# CITY OF PETALUMA

## ADDENDUM NO. 4

### Ellis Creek Water Recycling Facility Tertiary Filtration Expansion UV Disinfection Equipment Modifications Project City Project Number C66401416

November 17, 2022

VERIFY SCALES	JOB NO. 7310L.10
BAR IS ONE INCH ON ORIGINAL DRAWING	DRAWING NO. D01B
0 1"	SHEET NO. 22 OF 56
IF NOT ONE INCH ON THIS SHEET, ADJUST SCALES ACCORDINGLY

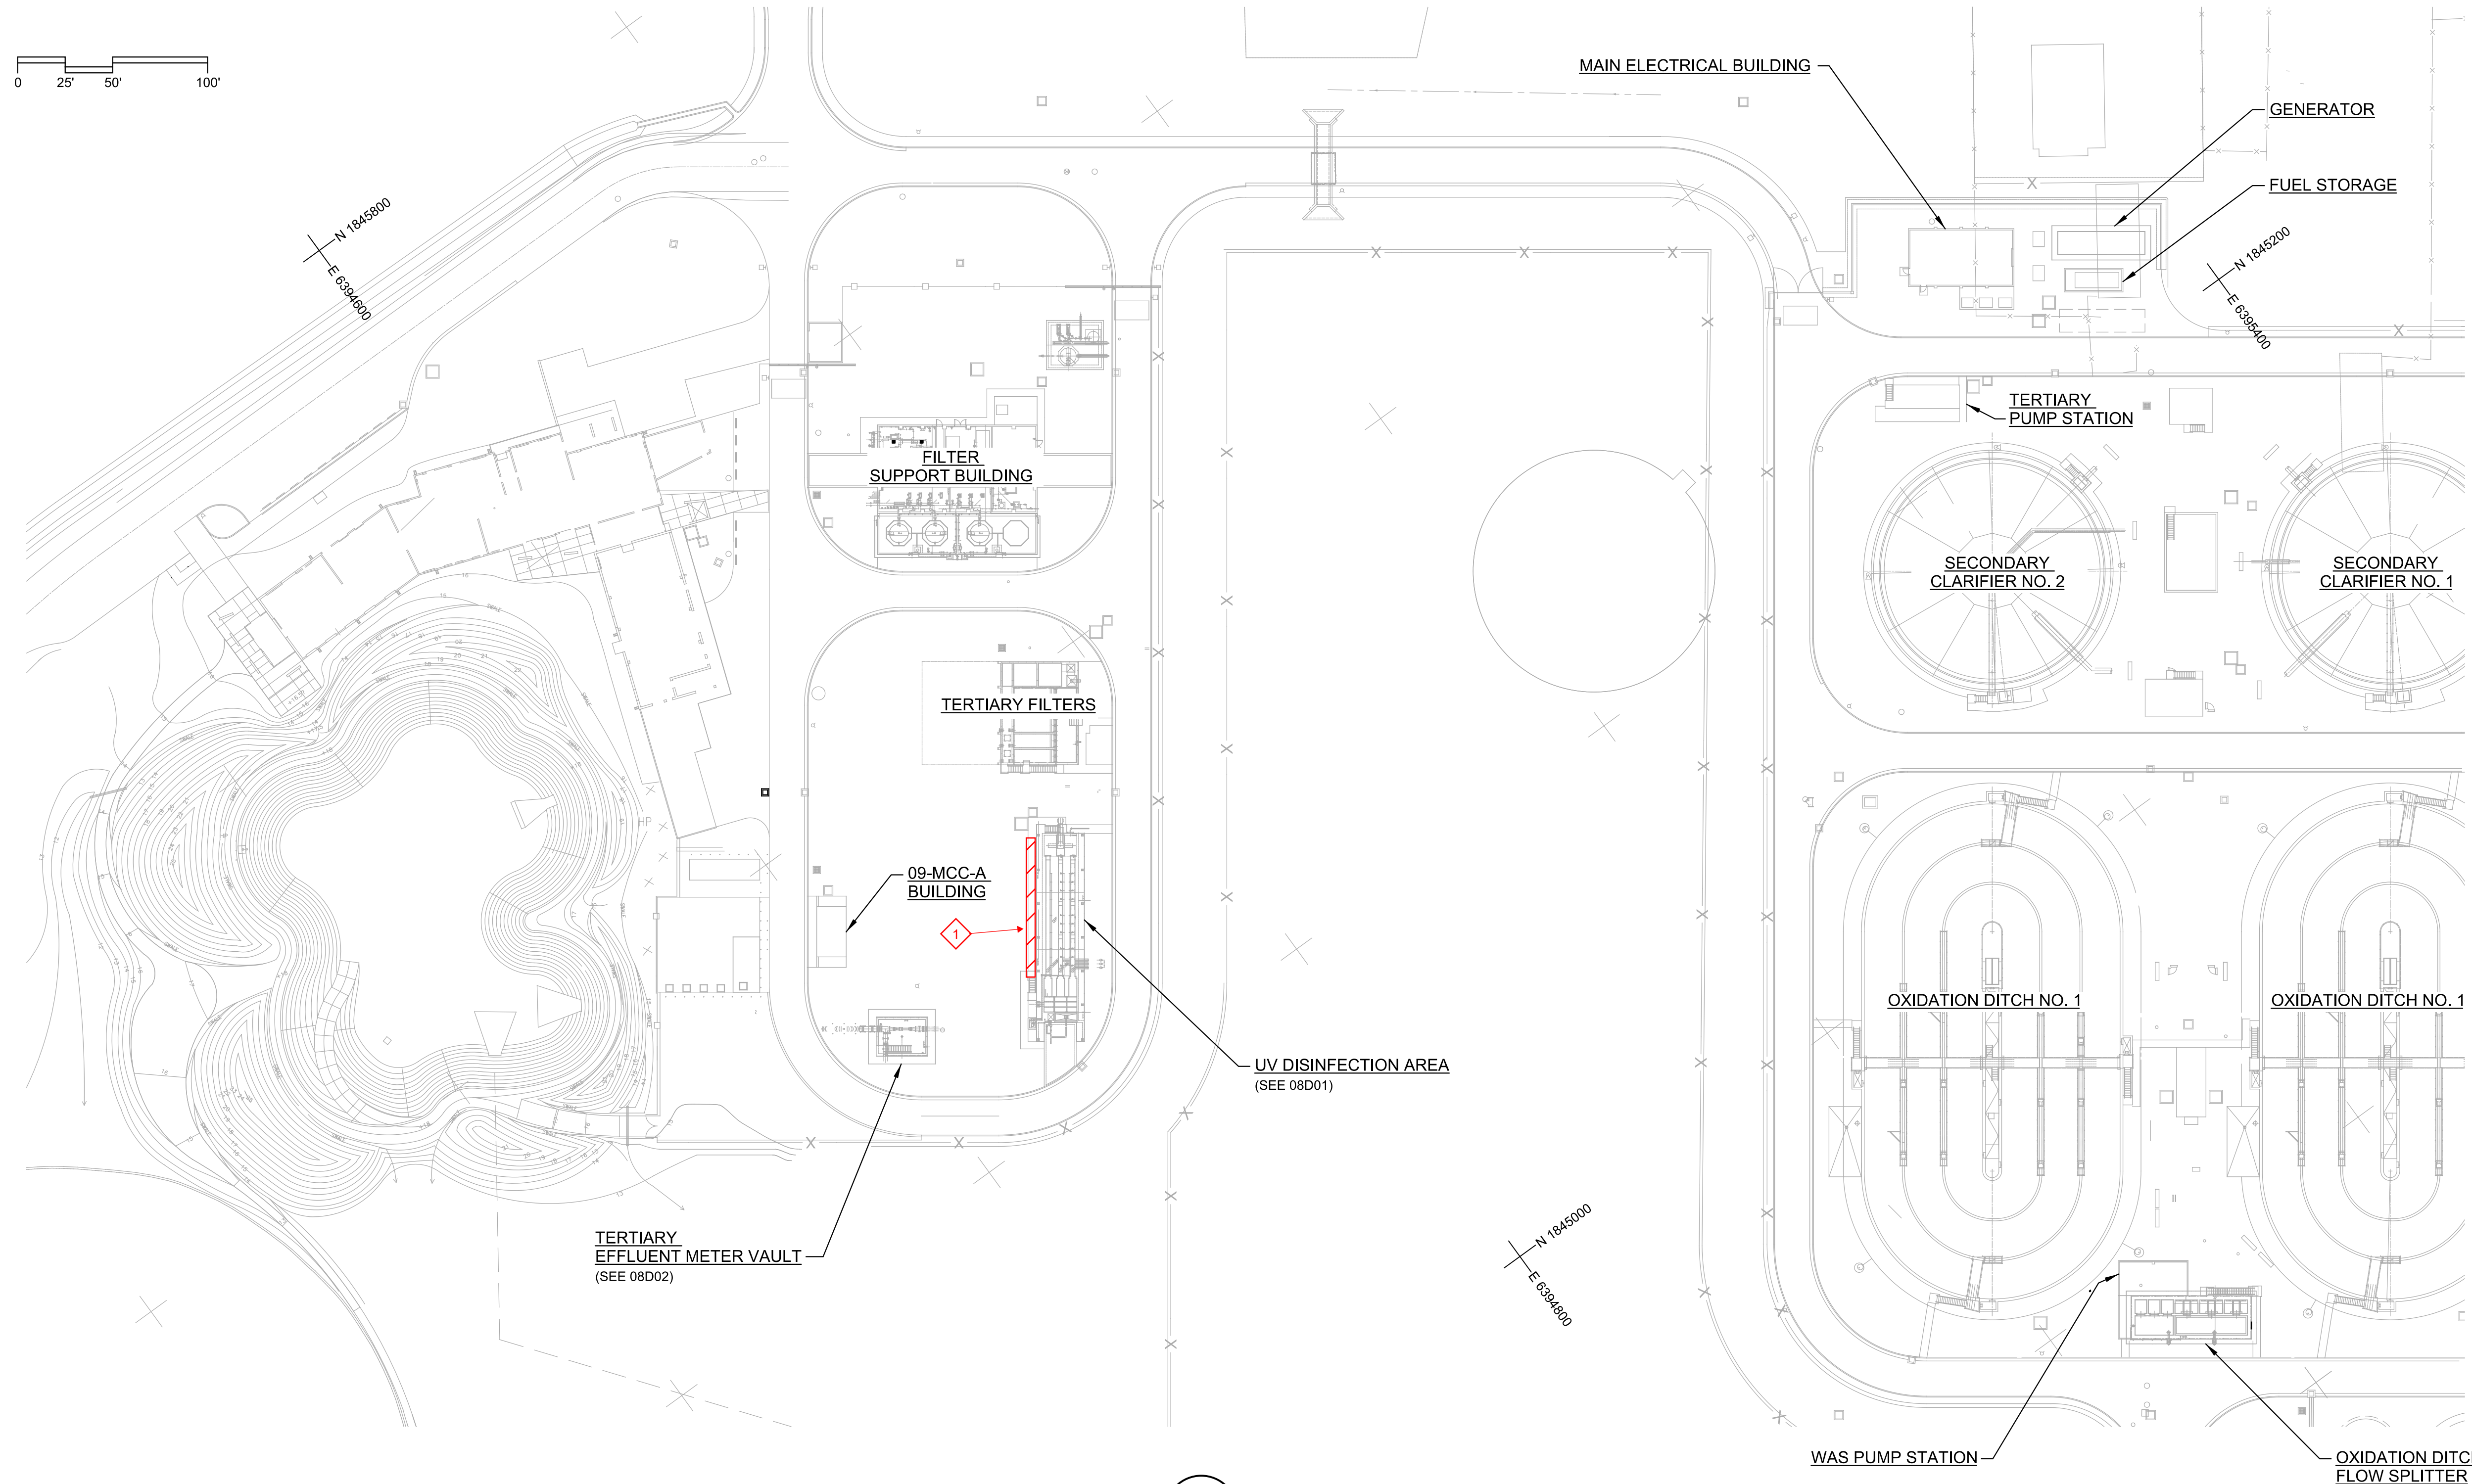
- KEY NOTES:**
- DEMOLISH SIDEWALK THAT RUNS ALONG WEST SIDE OF UV STRUCTURE TO ACCOMMODATE CANOPY SUPPORT.

JOB NO.  
7310L.10  
 DRAWING NO.  
**C02B**  
 SHEET NO.  
26 OF 56

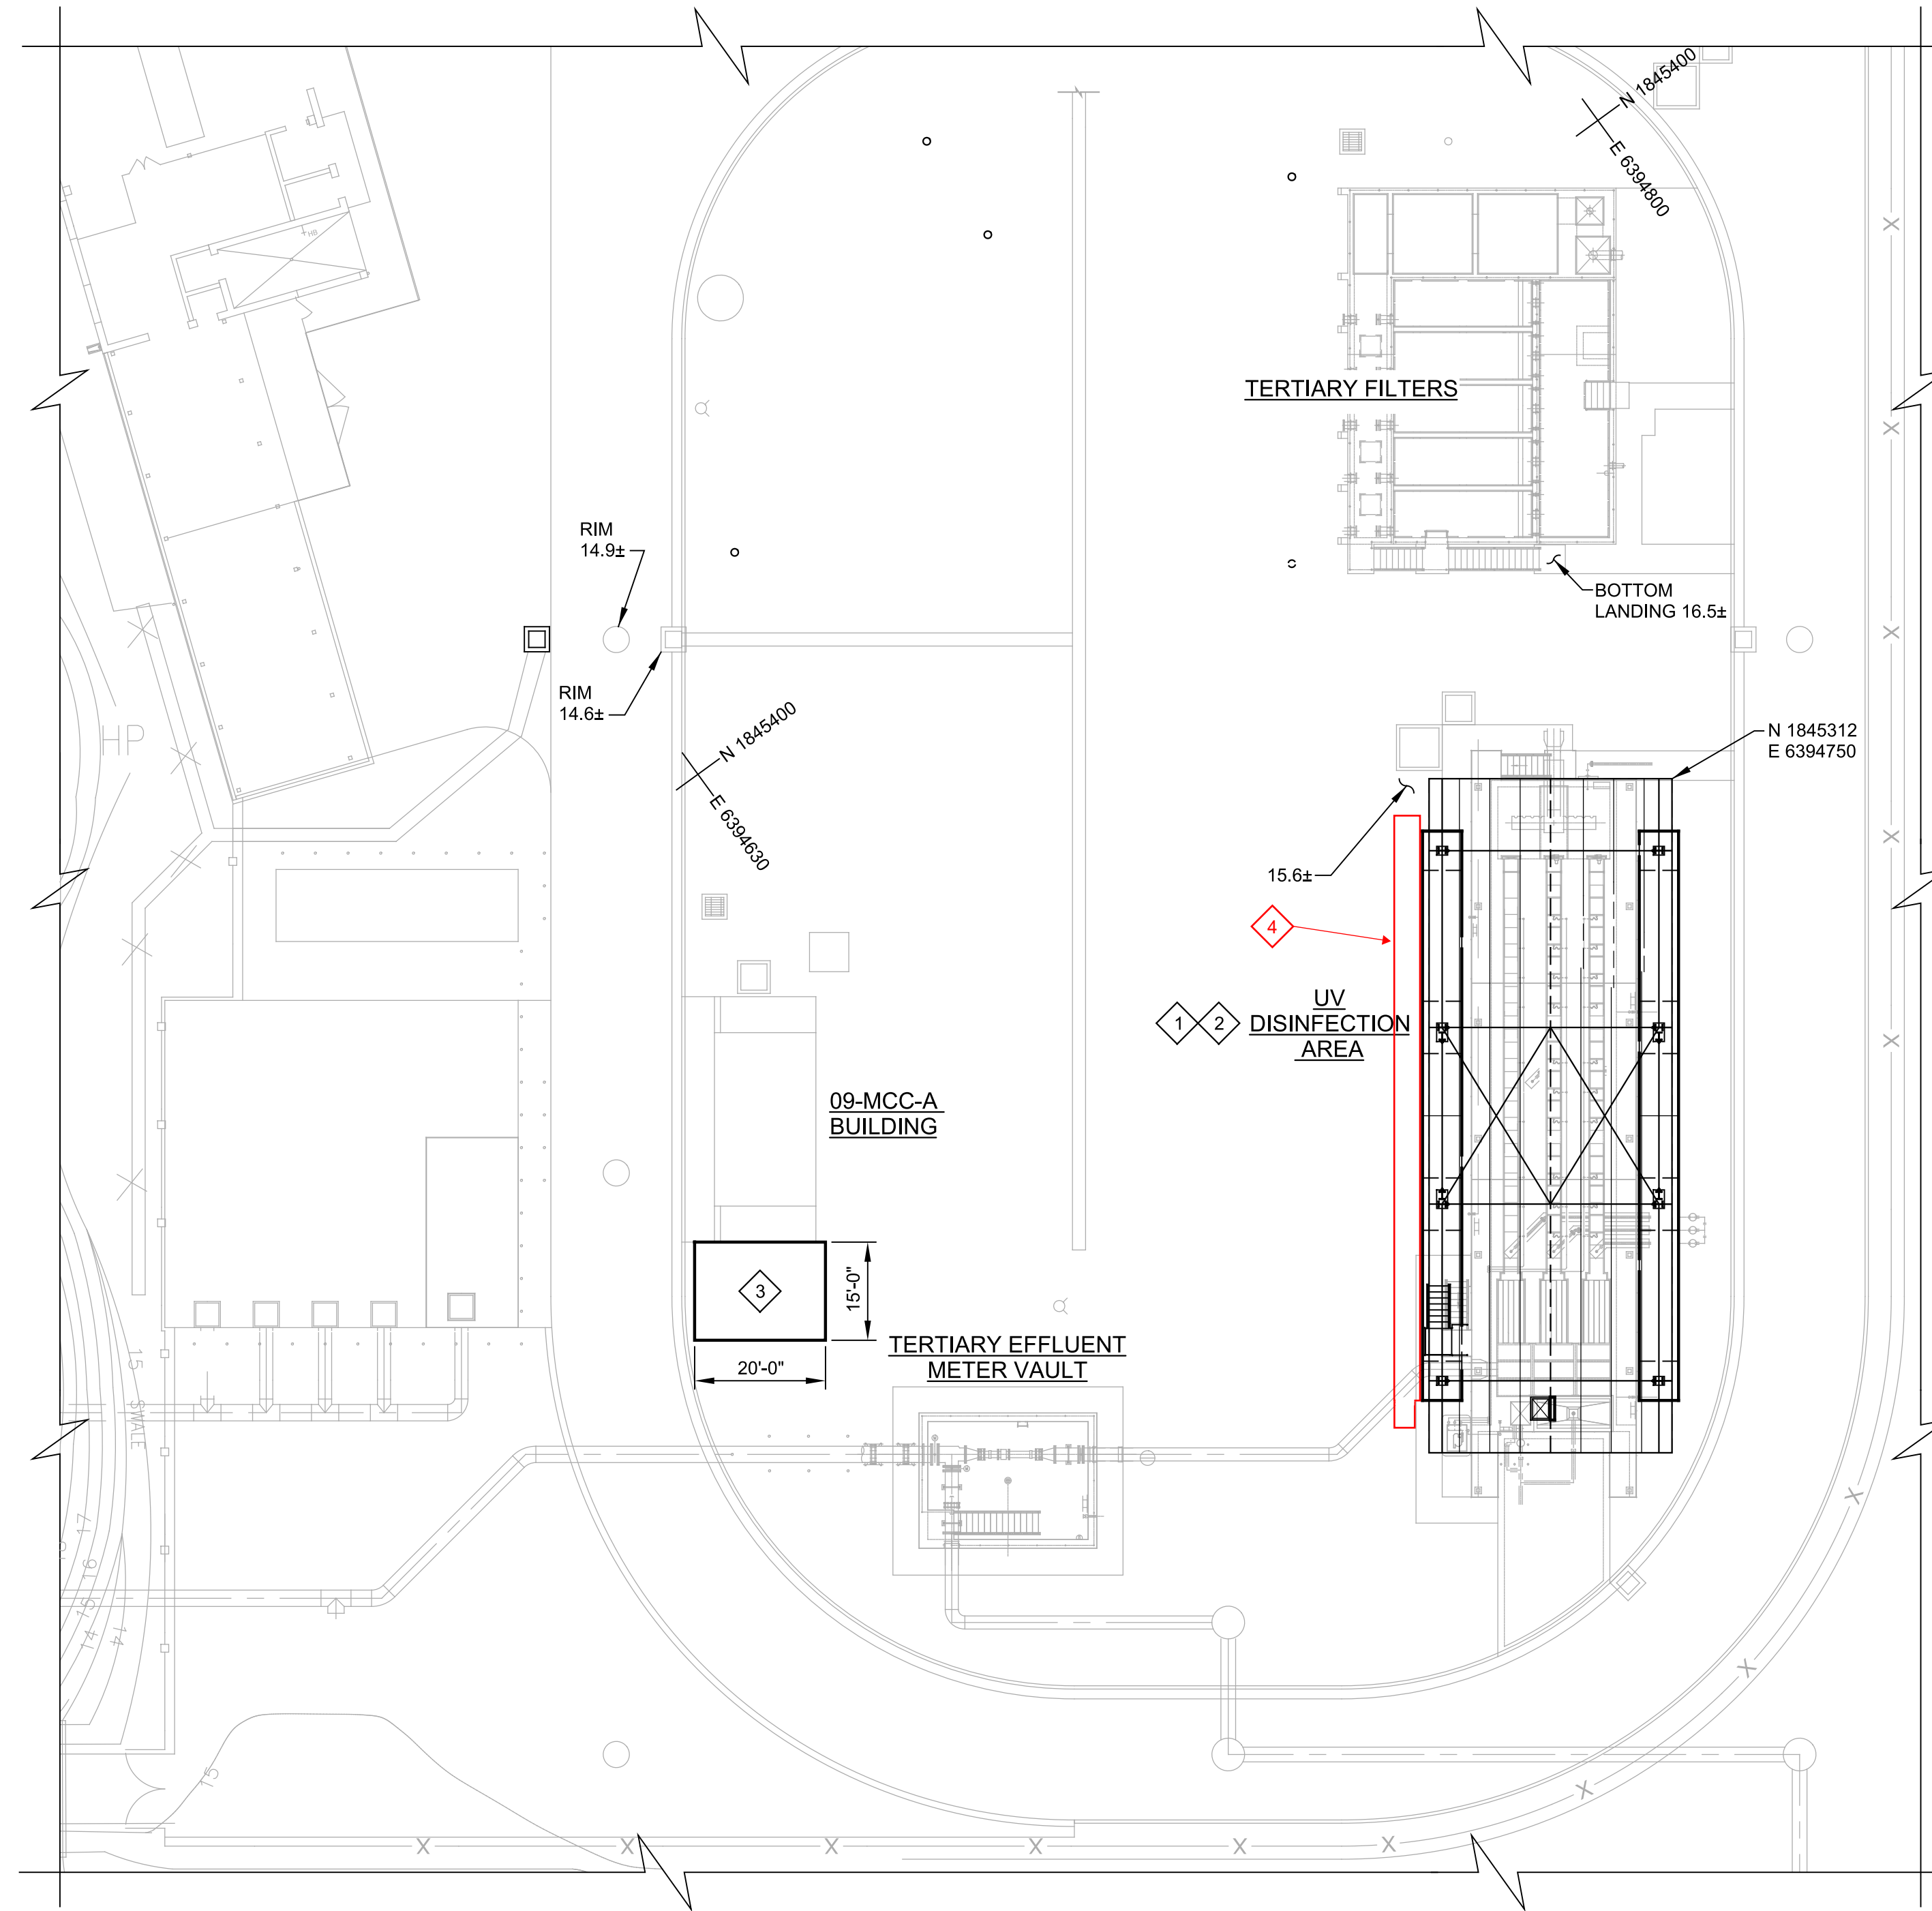
**Q: What is the plan for sidewalk demolition and restoration for the UV facility improvements? It looks like (E) sidewalk will need to be removed and relocated for construction of the NW canopy grade beam work.**

- 1 FINISH GRADE AROUND UV SHALL MATCH EXISTING, 16.5±.
- 2 UV DISINFECTION AREA, SEE DRAWING 08S01.
- 3 CONSTRUCT 15'-0" BY 20'-0" CONCRETE PAD AS SHOWN AND PER S300/TYP. PAD SHALL BE FLUSH WITH EXISTING WALKWAY ON NORTH SIDE AND SLOPE TO THE SOUTH FOR DRAINAGE. PROVIDE EXPANSION JOINT PER S130/TYP BETWEEN NEW AND EXISTING SLABS. GRADE AROUND THE NEW PAD SHALL REMAIN PER EXISTING GRADE.
- 4 **INSTALL SIDEWALK PER CR306/TYP ALONG WEST SIDE OF NEW CANOPY SUPPORT BEAM. TRANSITION TO EXISTING SIDEWALK PER CONTRACTOR'S RECOMMENDATIONS.**

A: Changes to the sidewalk demolition and restoration contract are included in this addendum.

**CF DUCT BANK SECTION (EXISTING)**

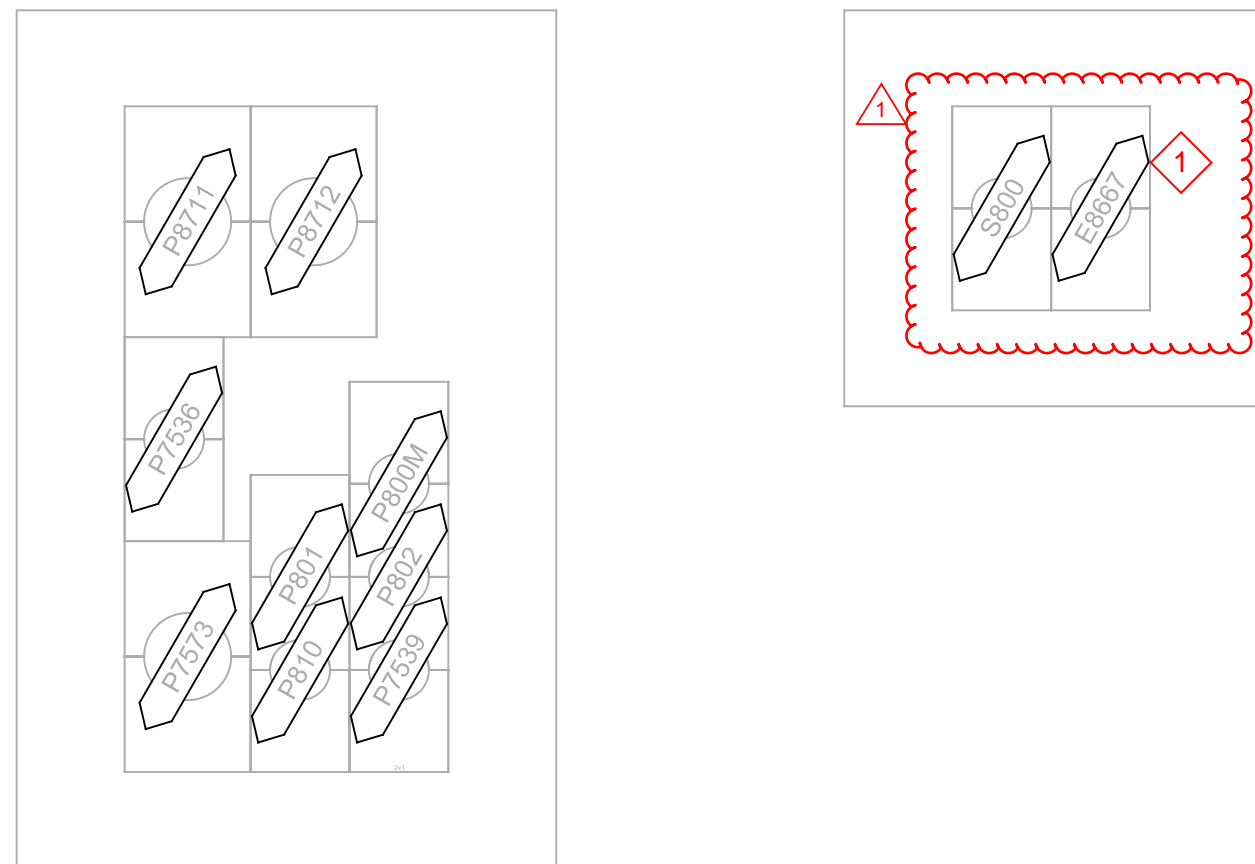
**KEY NOTES:**  
 1. EXISTING SPARE CONDUIT CONTINUES TO PLC-7. UPDATE CONDUIT TAG TO N8667.
